**Addendum No. 1**

**Subject:** General Louis Wagner Middle School Culinary Art Suite Renovation  
SDP Contract Nos. B-022C, B-023C, B-024C, B-025C

**Location:** General Louis Wagner Middle School  
1701 W Chelton Ave  
Philadelphia, Pennsylvania 19139

**This Addendum, dated 1 of April, 2021, shall modify and become part of the Contract Documents for the work of this project. Any items not mentioned herein, or affected by, shall be performed strictly in accordance with the original documents.**

1 DEMOLITION PLAN - CLASSROOM #209  
SCALE: 1/8" = 1'-0"

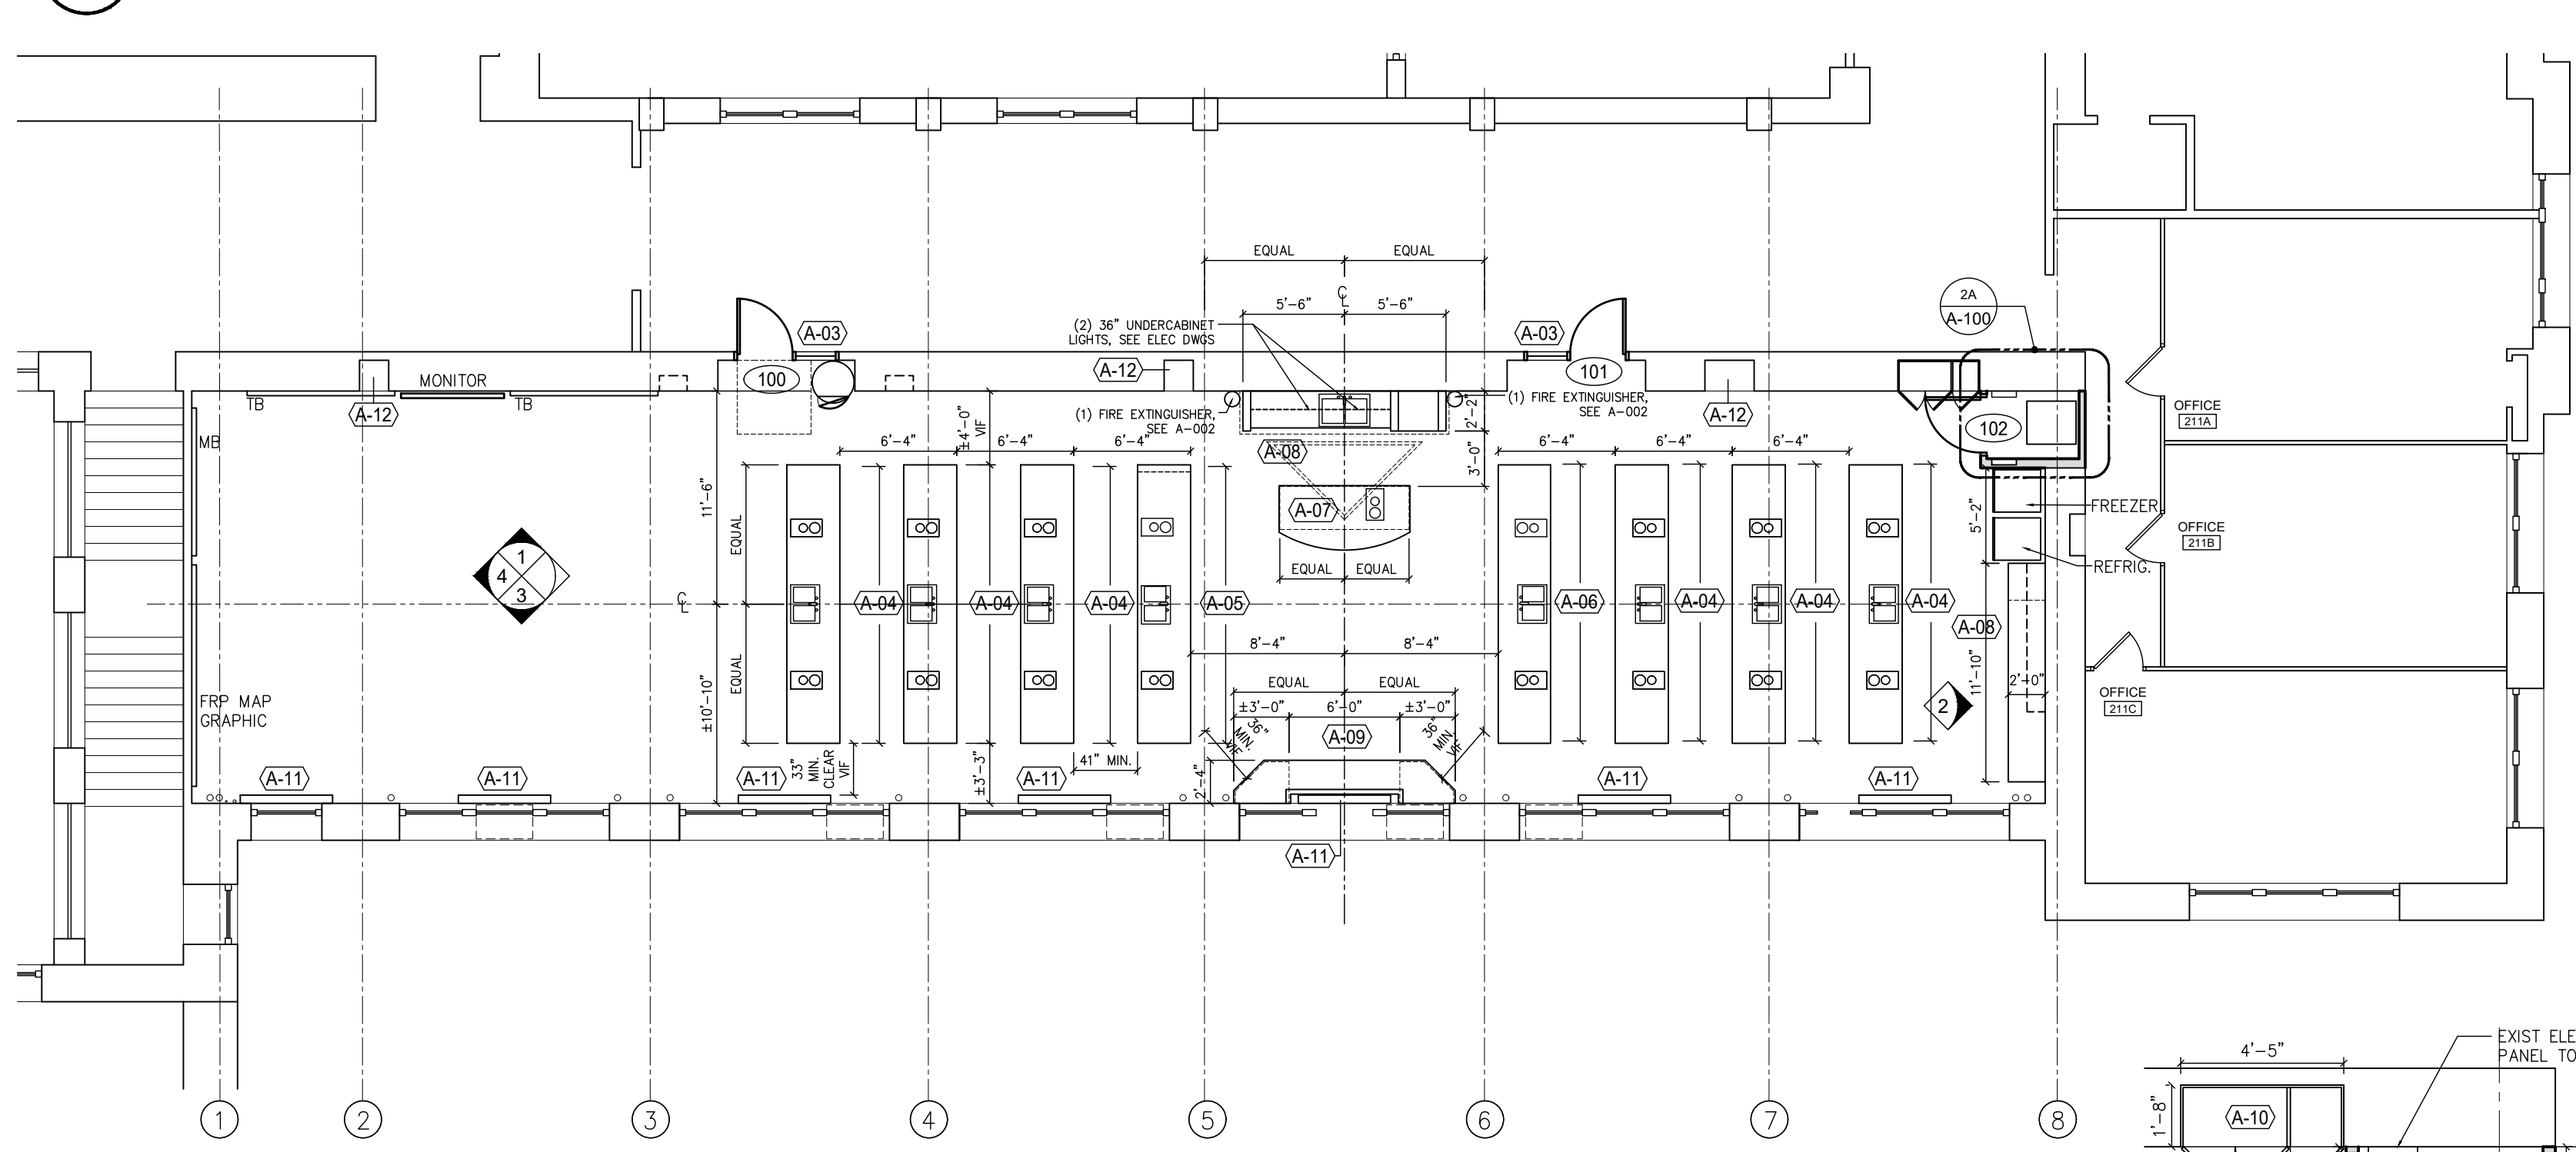
**Drawing: A-100 Demo, New Work, and Ceiling Plans**

- a. Demolition – Keynotes, modify note D03: “Remove portion of metal panel in upper window pane as req’d for new louver / A/C unit. Ref mech dwgs for more info.”
- b. Detail 1/A100-Demolition Plan – Classroom #209, add Demolition Keynotes D03, refer to revised drawings.
- c. Detail 3/A-100-New Reflected Ceiling Plan – Classroom #209, heat detectors added for reference, refer to revised drawings
- d. General Refl. Ceiling Plan Notes, add note #8 “Fire alarm devices / heat detectors shown on architectural RCPs are for reference only and to indicate important alignments. Reference electrical drawings for device types.”
- e. Reflected Ceiling Plan - Keynotes, modify keynotes RC-03 and RC-04 to indicate ceiling types, refer to revised drawings.

Question 10: On Drawing A-100, Detail #4, RC-04 is not referenced on the electrical drawings for the removal and reinstallation of the 1<sup>st</sup> floor lighting fixtures. Should it be or will a 1<sup>st</sup> floor drawing be added for the electrical set of drawings to show that scope of work?

Question 11: On drawing A-100, Detail #3, the ceiling mounted fire alarm devices are not indicated. Will they be added for coordination purposes?

**Answer 10: Existing 1<sup>st</sup> floor lighting fixtures are to remain and be temporarily suspended during work, reference Reflected Ceiling Plan Keynote RC-04 on sheet A-100.**

**Answer 11: Yes, fire devices will be indicated on A-100, Detail #3 for reference only, see Addendum 1.**

1 INTERIOR ELEVATION  
A-300 SCALE: 1/4" = 1'-0"

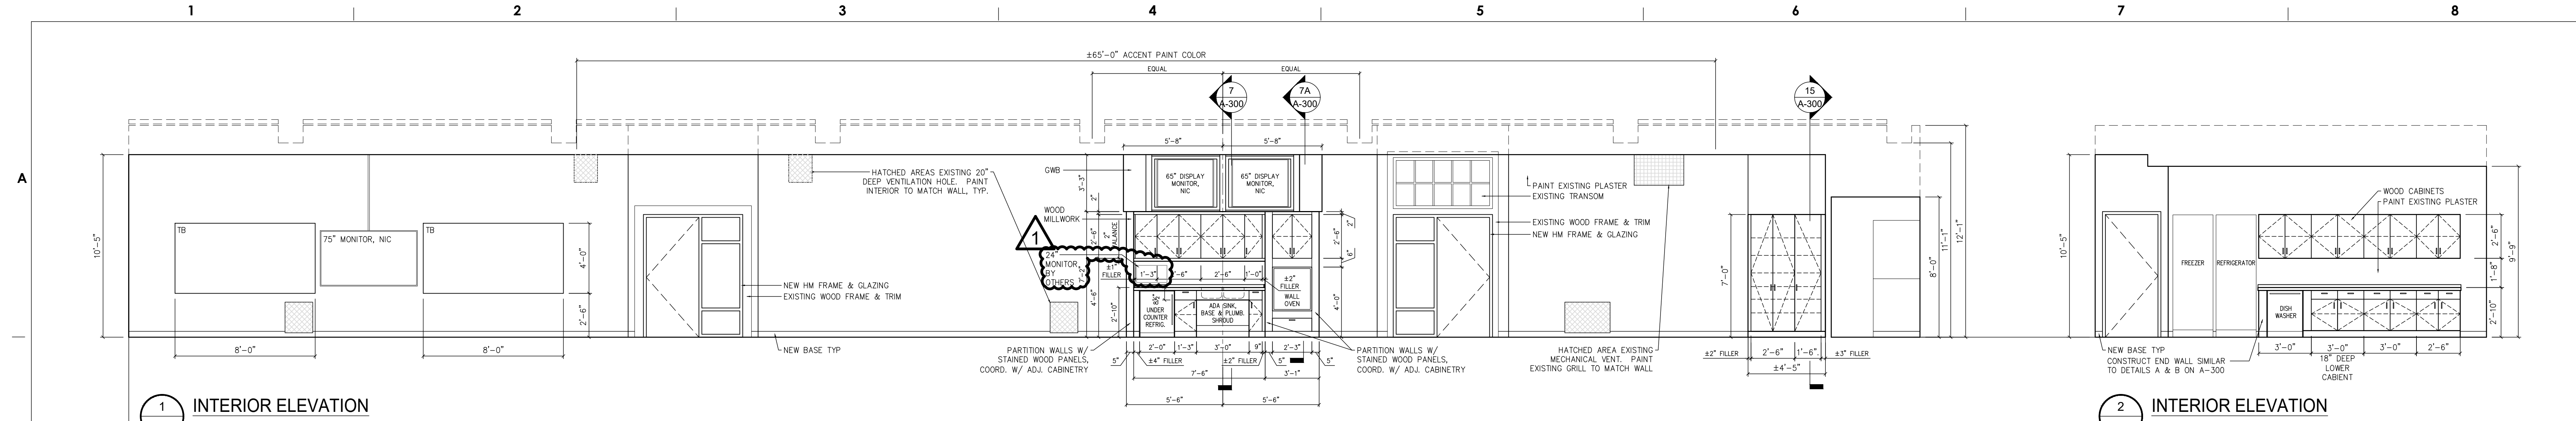
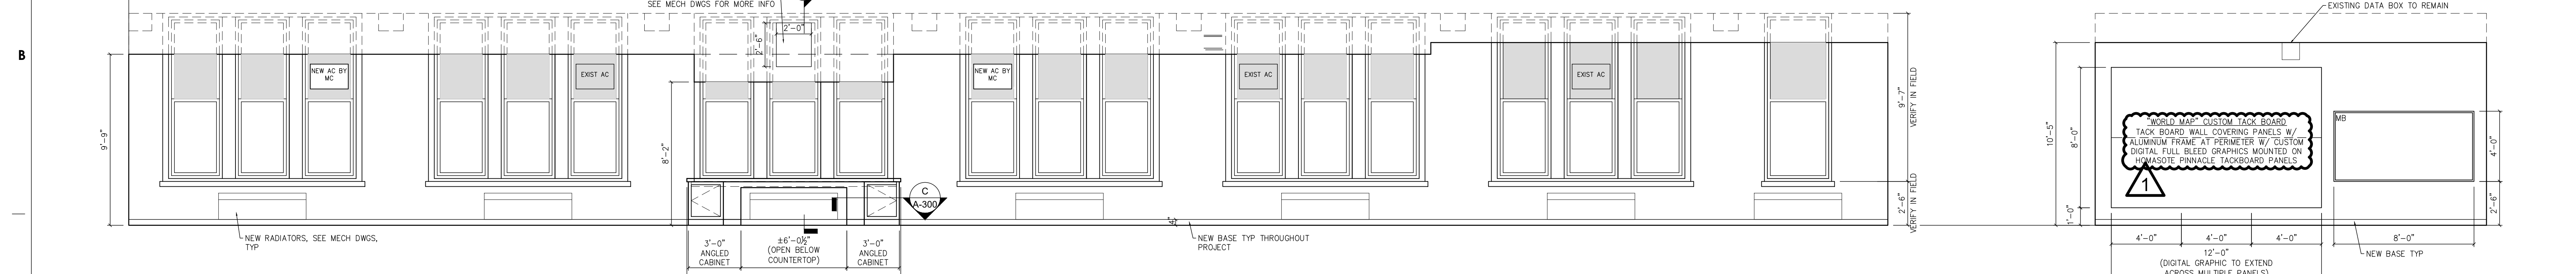
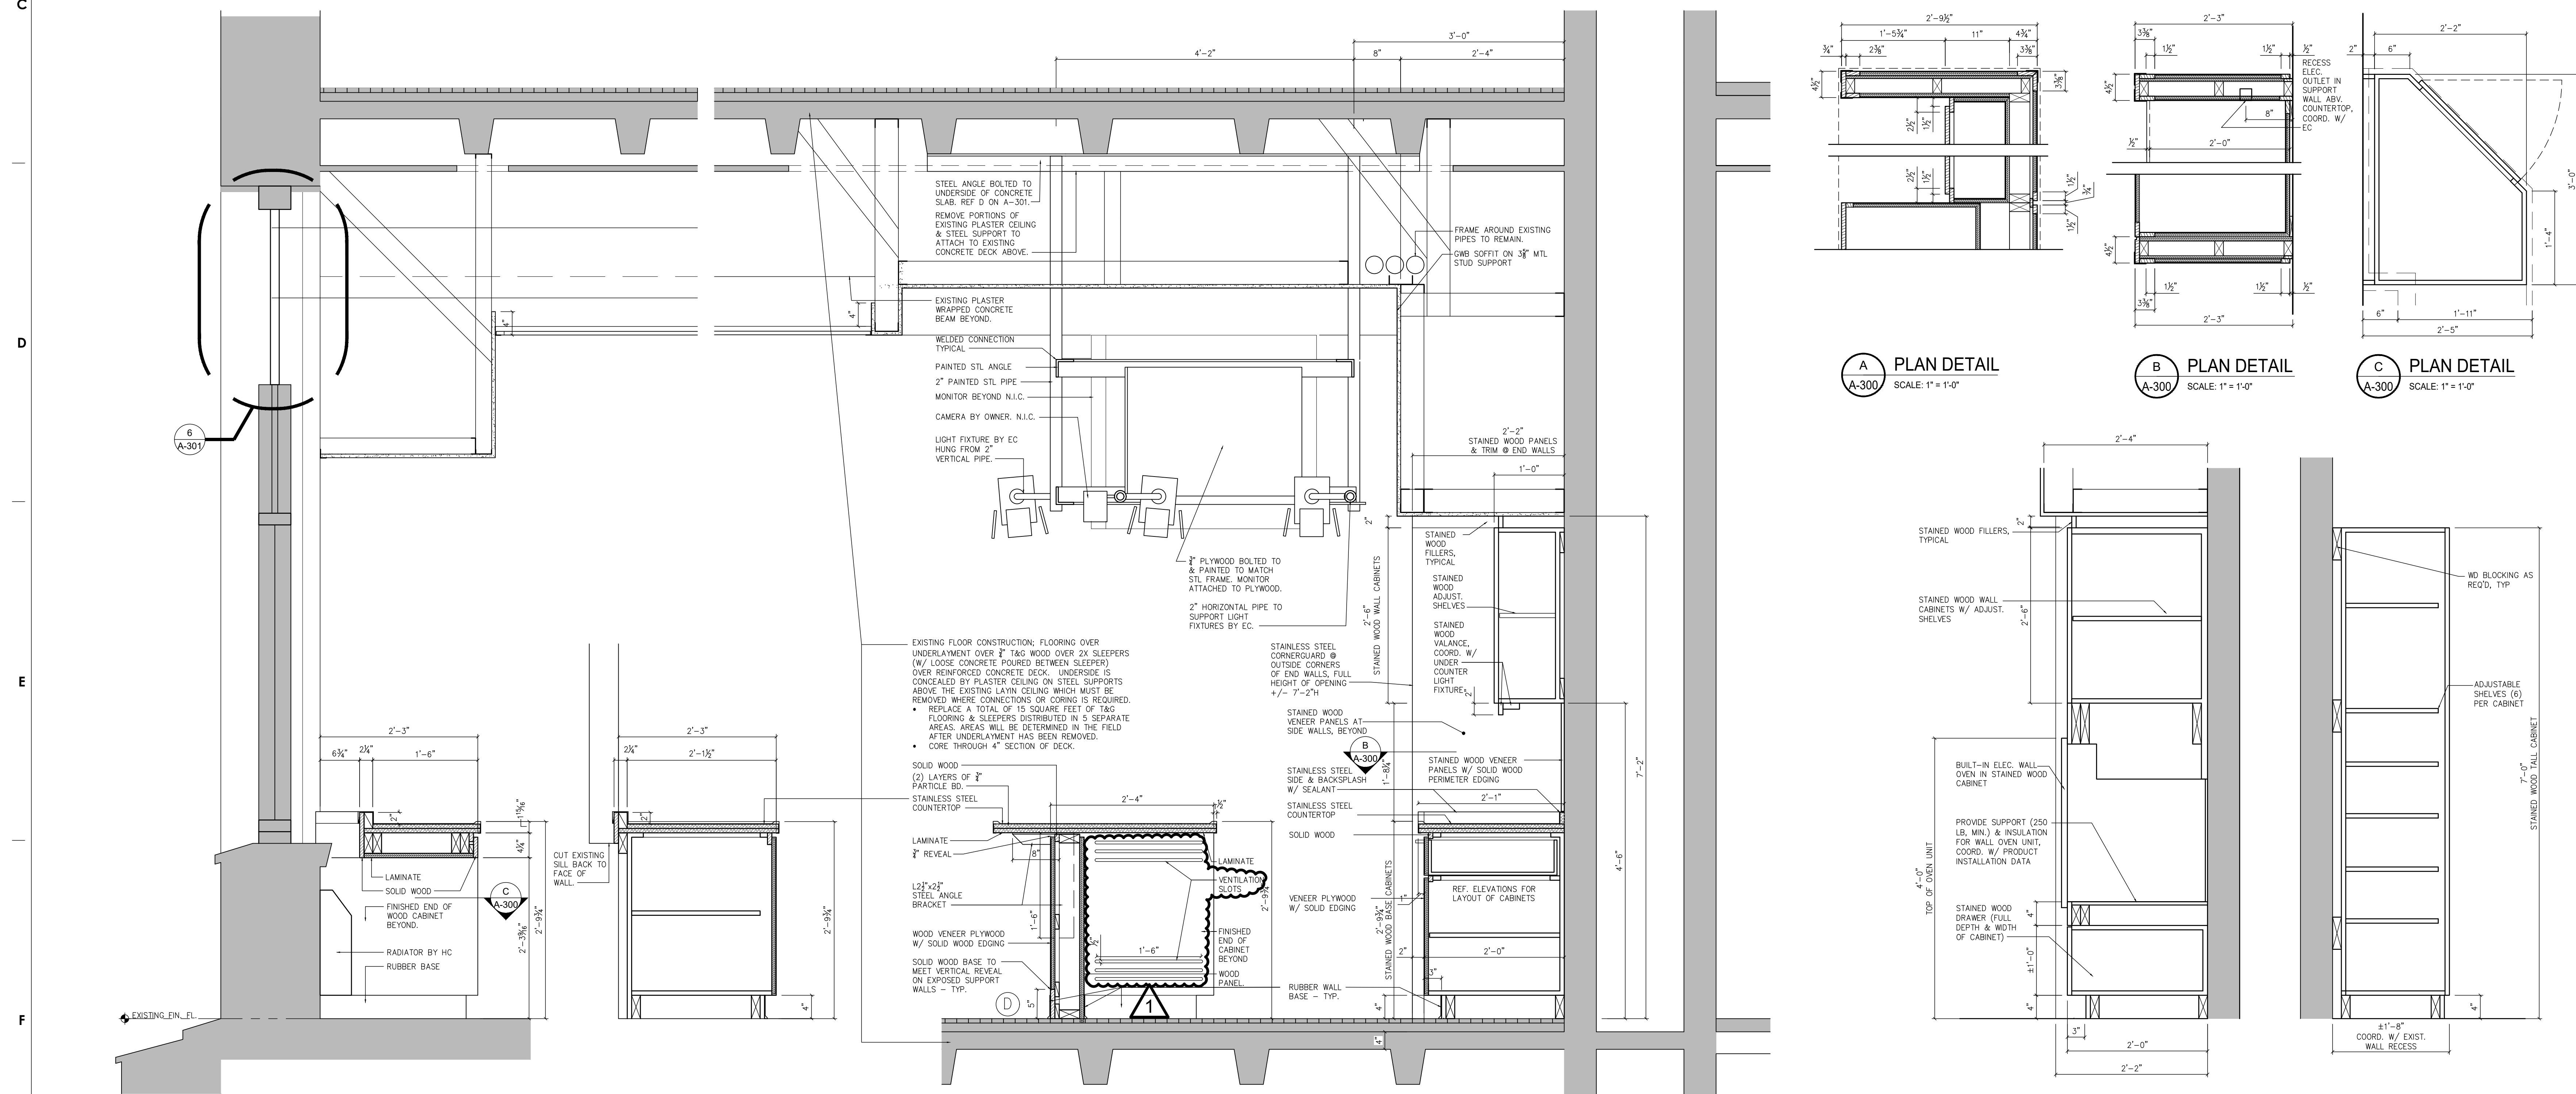
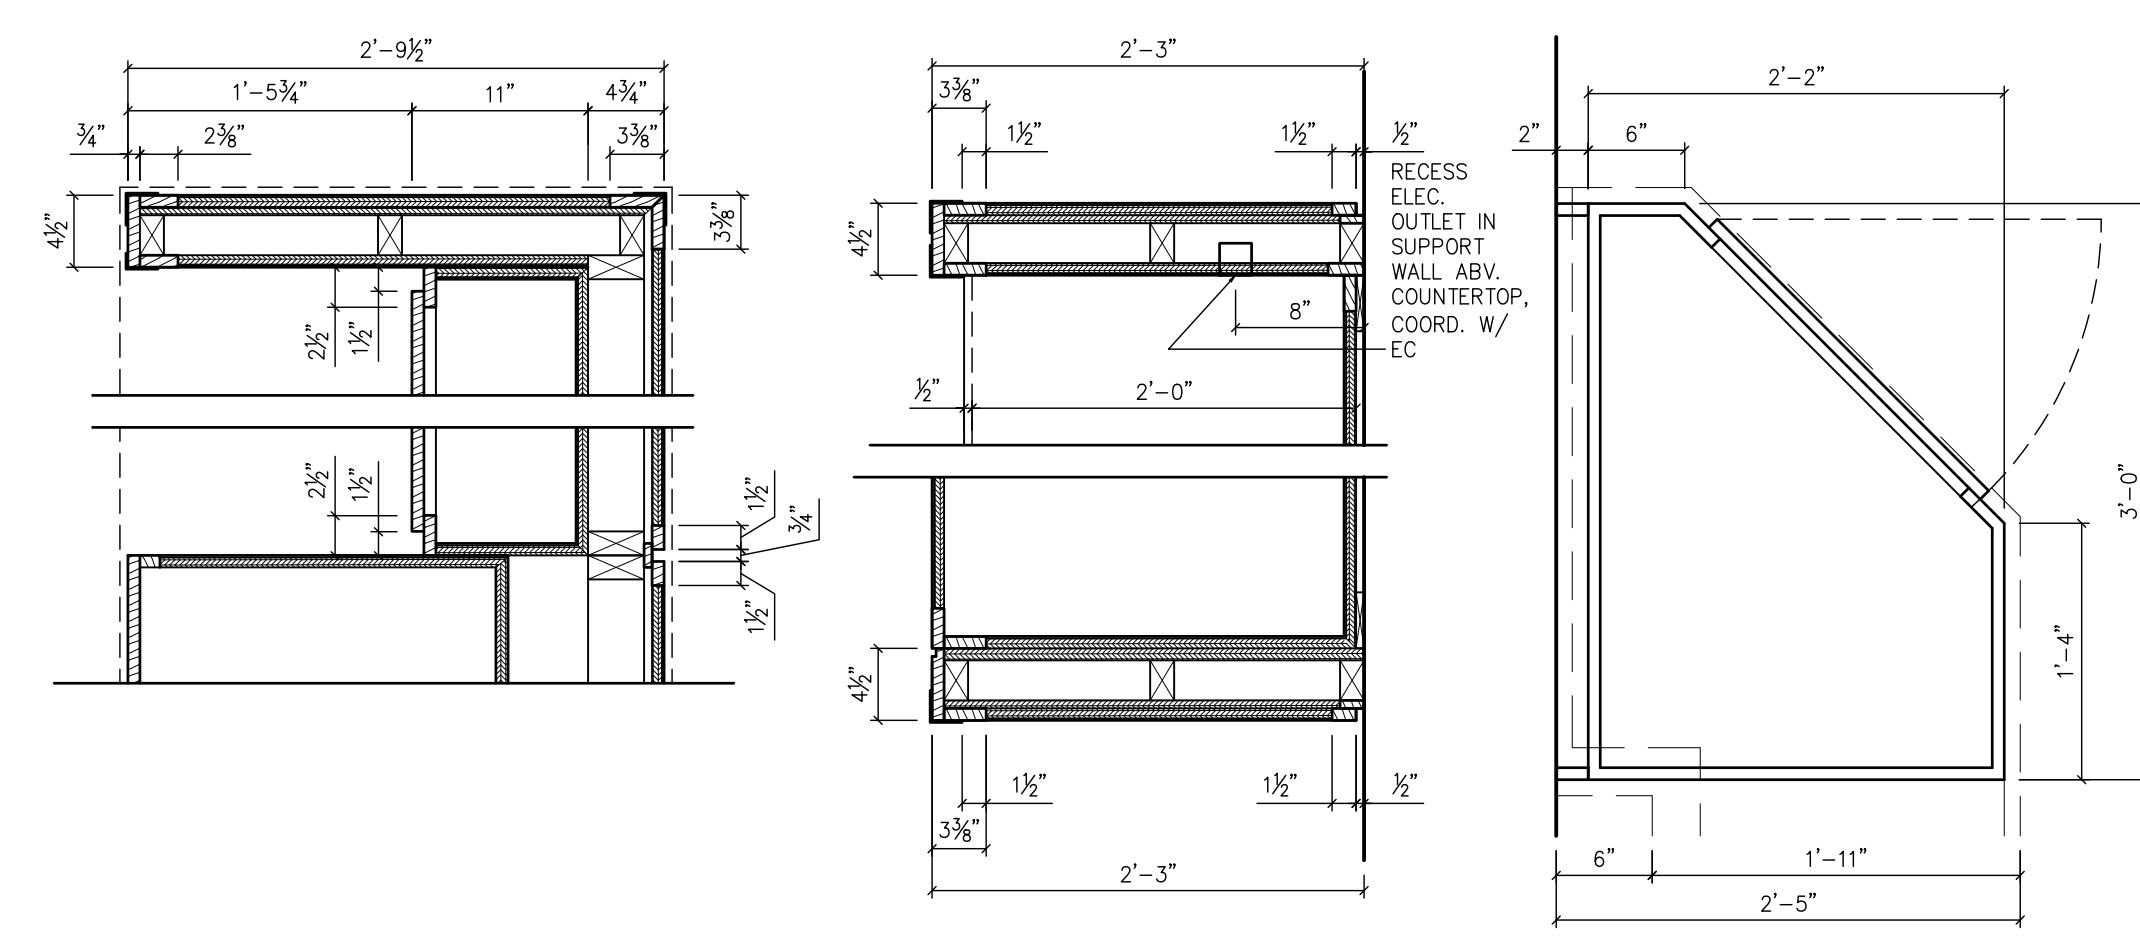
**Drawing: A-300 Interior Elevations, Wall Sections, and Millwork Details**

- a. Detail 1/A-300 – Interior Elevation, add 24” Monitor By Others, refer to revised drawings
- b. Detail 4/A-300 – Interior Elevation, edit existing note to read: ““World Map” Custom Tack Board: Tack board wall covering panels w/ aluminum frame at perimeter w/ custom digital full bleed graphics mounted on homasote pinnacle tackboard panels.”
- c. Detail 7/A-300 – Section Through Instructor’s Demonstration Area, ventilation slots added to millwork face for new data rack, refer to revised drawings

Question 15: On Drawing A-300, detail #7, who removes the 2<sup>nd</sup> ceiling to allow access above the instructor's station to allow access to the concrete slab? Do the cameras require rough-in? If so will they be provided by others to complete the work over the station?

**Answer 15: GC is to remove the plaster ceiling for access to concrete slab. Cameras to be installed by separate SDP vendor.**
